ANDELINA RIDGE JSP13-12

Public hearing at the request of Pinnacle- Novi 12 LLC for Preliminary Site Plan utilizing the Open Space Preservation Option, Phasing Plan, Woodland Permit, Wetland Permit and Stormwater Management Plan approval. The subject property is 64.0 acres in Section 18 of the City of Novi and located south of Twelve Mile Road and east of Napier Road in the R-4, One-Family Residential District. The applicant is proposing a 146 unit development using the Open Space Preservation Option.

PLANNING REVIEW

SUBJECT: Andelina Ridge, JSP13-0012; Preliminary Site Plan, Phasing Plan, & Traffic Impact Study, PSP13-0051; Traffic Review

RESIDENTIAL DEVELOPMENT ENTRANCE LIGHTING OPTIONS

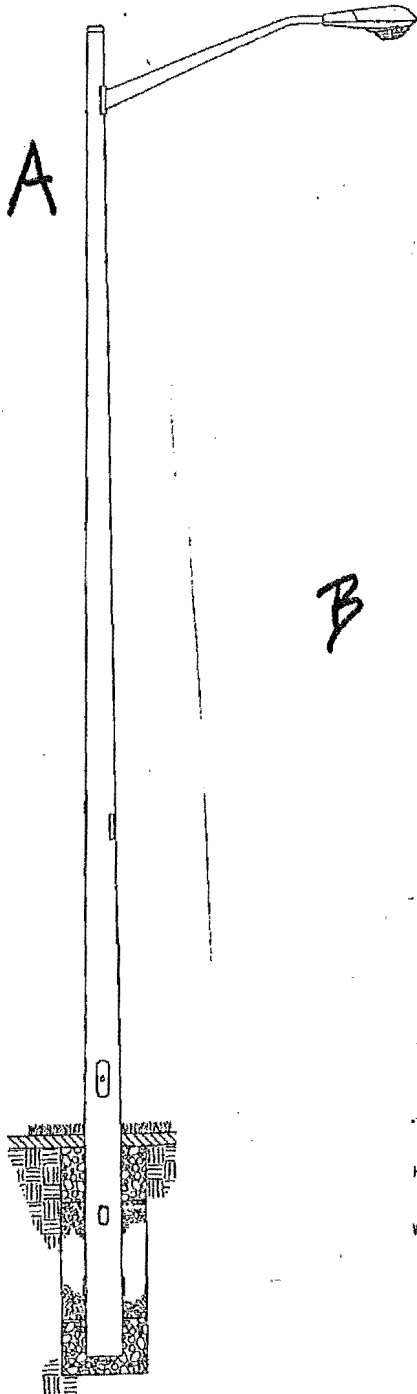
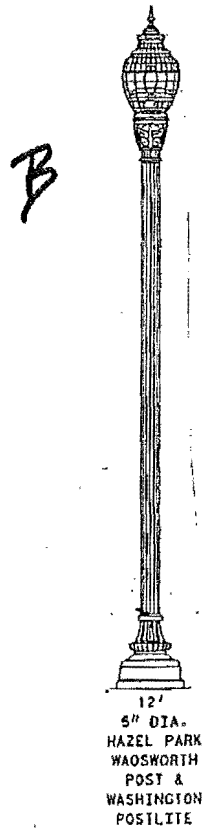
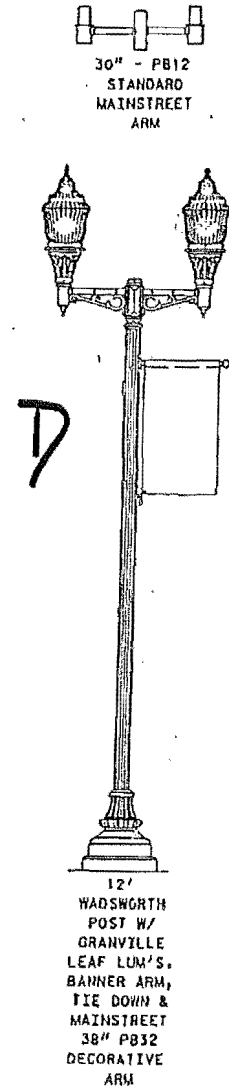
8. Lighting: The City Council recently passed a text amendment requiring an entrance light at all residential developments. **The applicant should send via email a plan showing the location of a proposed entrance light. Once the proposed location has been approved by the Planning Division, the applicant should contact Adam Wayne (248.735.5648) in the Engineering Division to begin the process of working with the City and DTE on the installation of the entrance light.** Attached are the options available through DTE for residential development entrance lighting.

Figure 3. Knightsbridge Gate Pool House Site Plan

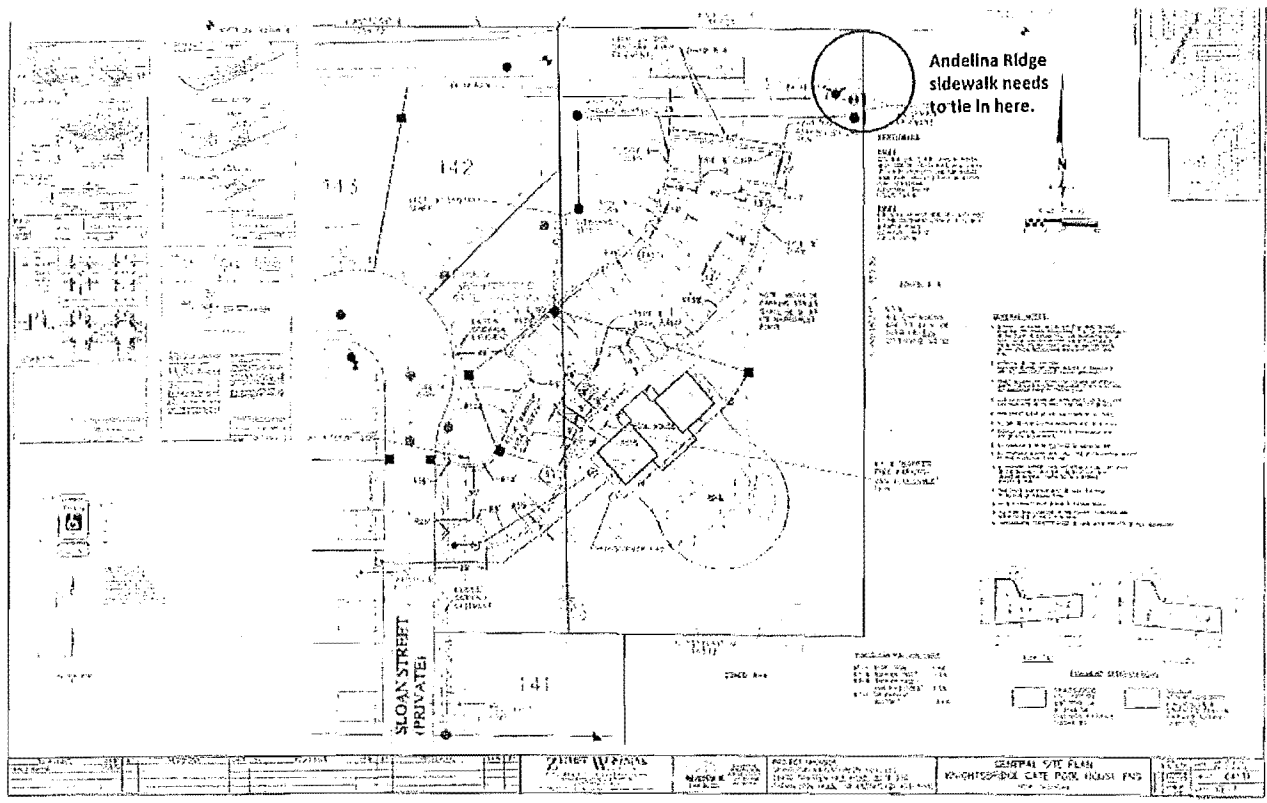
16. **The proposed provision of a 5-ft-wide concrete sidewalk along the site's 12 Mile Road frontage is consistent with the City's Bicycle & Pedestrian Master Plan. This sidewalk needs to transition via a smooth curve to the approved sidewalk to the west, which will be located 1 ft north of the neighboring 33-ft half right of way (Figure 3).**

L-1

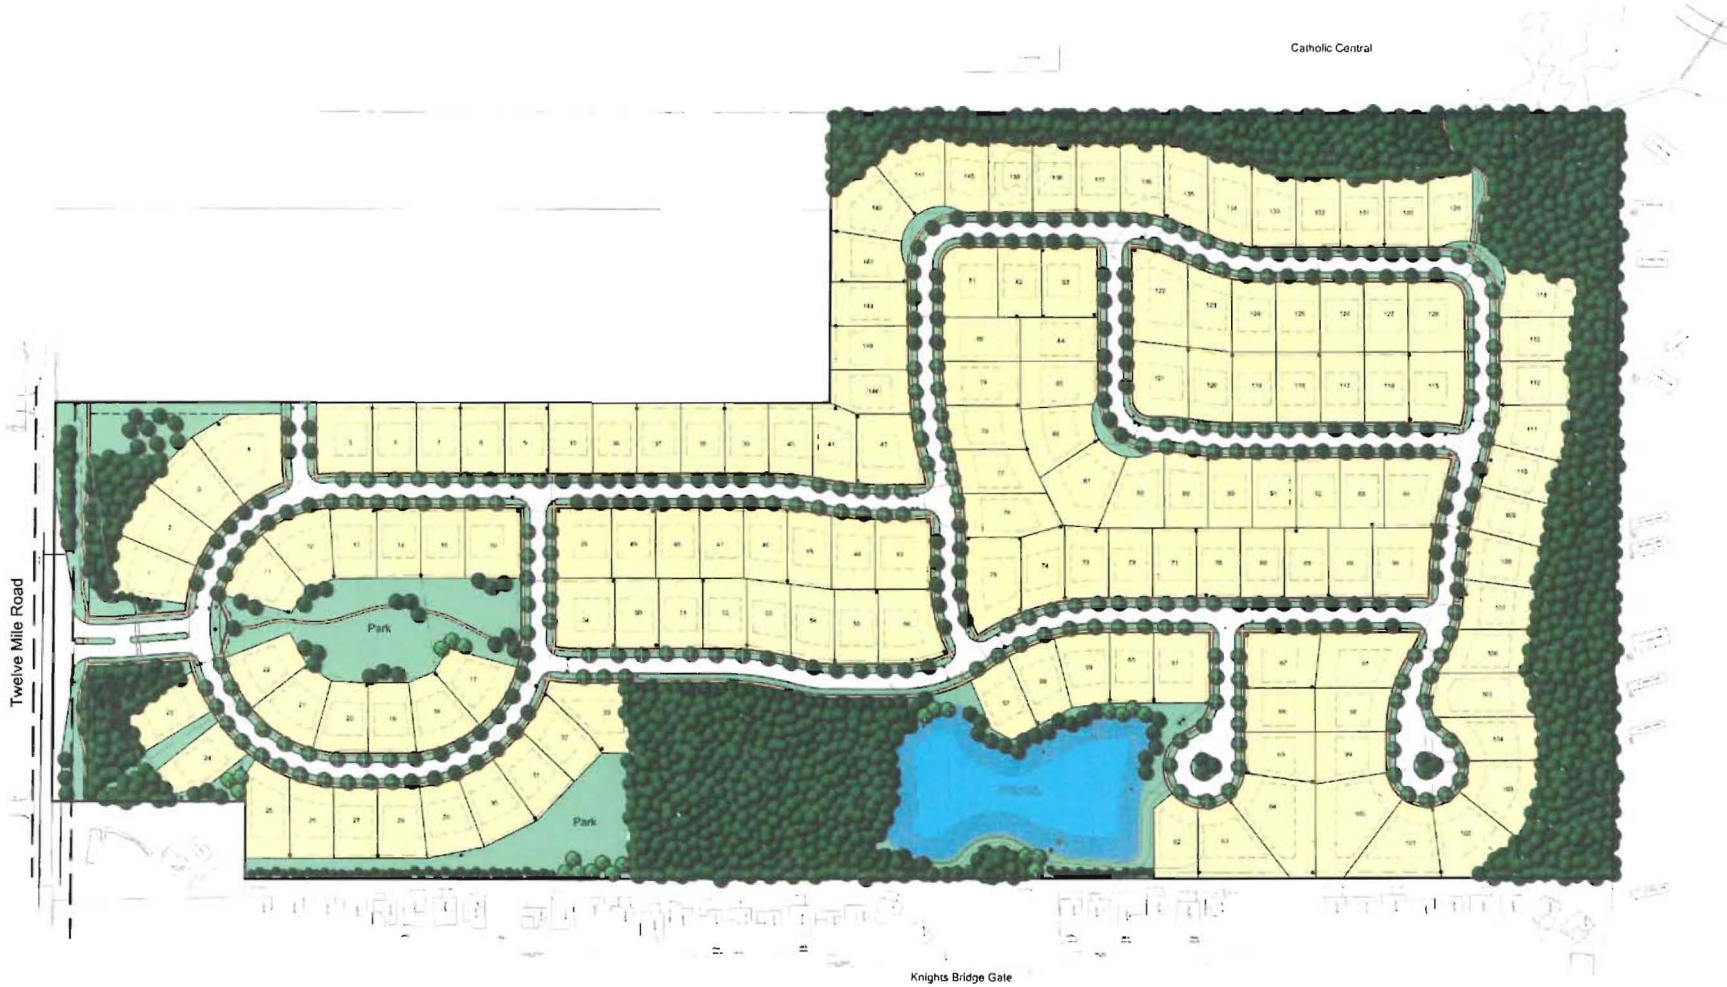
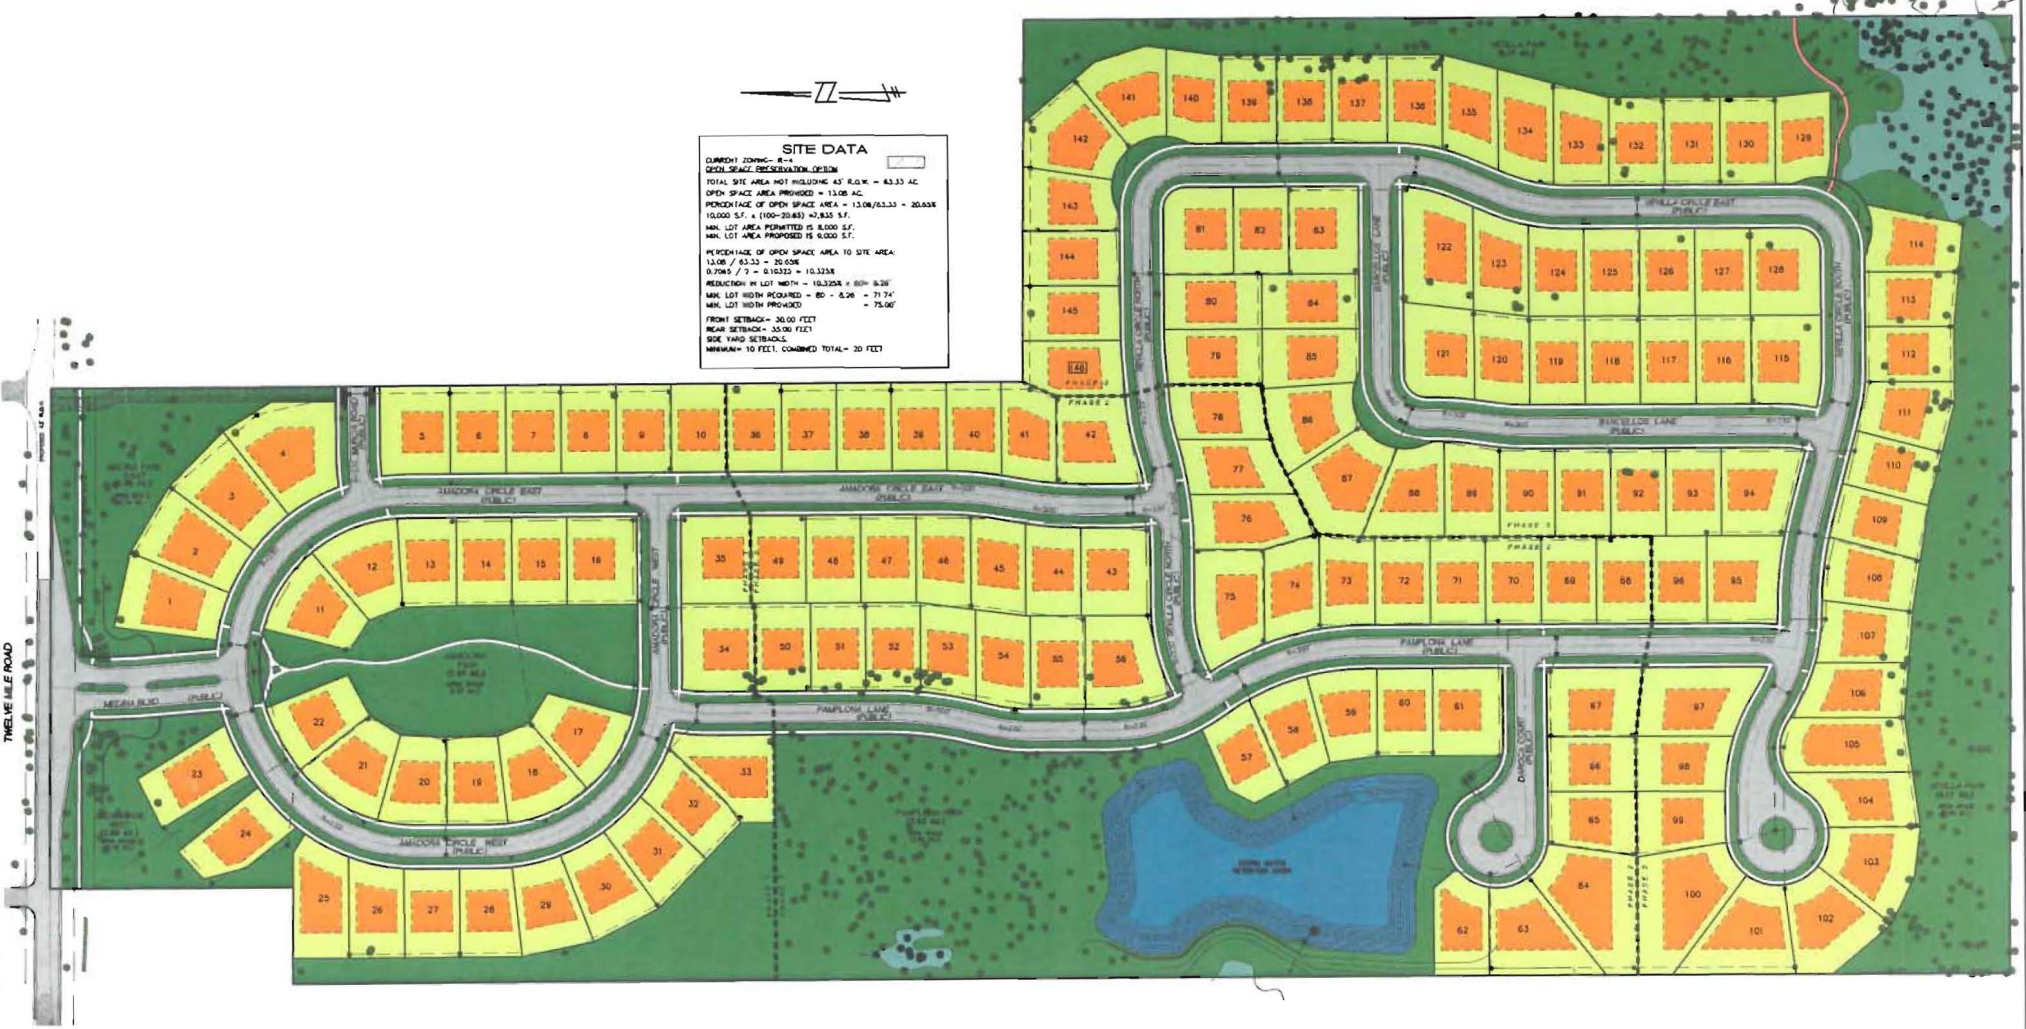
Per the summary provided on Sheet L-1 (*Landscape Plan*), 350 total tree replacement credits will be provided on site. The Plan proposes to accomplish this through the following plantings:

The Plan is seeking 1.5 replacement credits for the 10'-12' evergreens, 2.0 credits for each 12'-14' evergreen, and 2.5 replacement credits for each 14'+ evergreen.

It should be noted that the increased credits for planting larger-sized vegetation applies only to Landscape plantings and not to Woodland Replacement plantings. ***The Planning Commission will need to determine if a waiver shall be permitted under the ordinance for greater credit for upsized woodland replacement plantings.***

3. One of the species listed in *Replacement Plant List* on the *Landscape Plan* (Sheet No. L-1) is not acceptable as a Woodland Replacement Tree species in Novi. The species are not listed as accepted species in the City of Novi's *Woodland Tree Replacement Chart* found in the *Woodland Ordinance* (Chapter 37) or in the *Suggested Plant Materials List* found in the City of Novi's *Landscape Design Manual*. This should be addressed in subsequent site plan submittals. The species is:
